Access Compliance Report

(Curb Ramps)

Intersection ID: 17046	Main Street: ANNLIN_AV	Cross Street: SCALEYBARK_RD	Location: N
ADA ID: A31B0B0DF80D	Ramp Type: PerpDiag	Initial Pass/Fail: Fail	Overall Compliance: No
Codes/Mitigation Info/Possible Solution		Field Measurements/Component Compliance

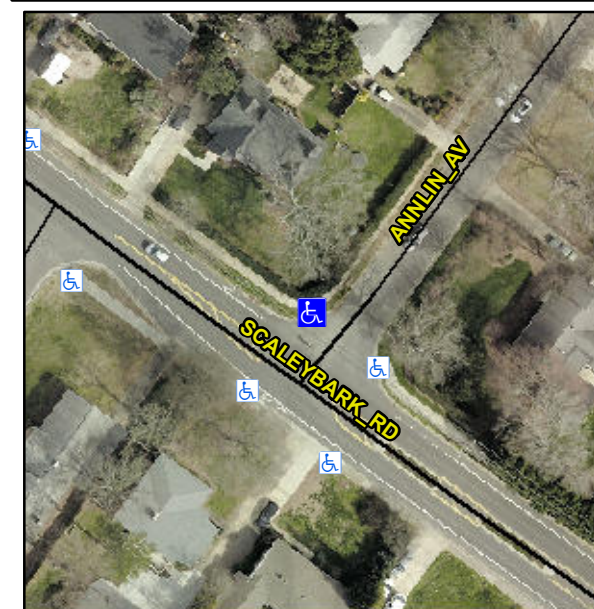
Not Found, R304.5.1, R304.2.2

Compliance	Description	Data	Compliance	Description	Data
N/A	Ramp Length (in)	47.0	No	Ramp Slope (%)	15.6
No	Ramp Width (in)	47.5	Yes	Ramp XSlope (%)	1.7
N/A	Flare Type LT	N/A	N/A	Flare Type RT	N/A
N/A	Flare Slope LT (%)	N/A	N/A	Flare Slope RT (%)	N/A
N/A	Flare Traversable LT?	N/A	N/A	Flare Traversable RT?	N/A
N/A	Landing Length (in)	N/A	N/A	DWS Provided?	N/A
N/A	Landing Width (in)	N/A	N/A	DWS Contrast?	N/A
N/A	Landing Slope (%)	N/A	N/A	DWS Length (in)	N/A
N/A	Landing X Slope (%)	N/A	N/A	DWS Full Width?	N/A
N/A	Landing Curb? (Y/N)	N/A	N/A	DWS Offset (in)	N/A
N/A	Shared Landing?	N/A			
N/A	Gutter Ponding?	N/A	N/A	Gutter Slope (%)	N/A
N/A	Gutter Lip Ht (in)	N/A	N/A	Gutter X Slope (%)	N/A
N/A	Painted X Walk1?	No	N/A	Painted X Walk2?	No
	X Walk 1 Direction	To SW		X Walk 2 Direction	To SE
N/A	X Walk 1 Width (in)	N/A	N/A	X Walk 2 Width (in)	N/A
	X Walk 1 Slope (%)	5.7		X Walk 2 Slope (%)	1.5
	X Walk 1 X Slope (%)	1.8		X Walk 2 X Slope (%)	2.6

Remove & Replace Curb Ramp With Two New Directional Ramps or Equivalent.
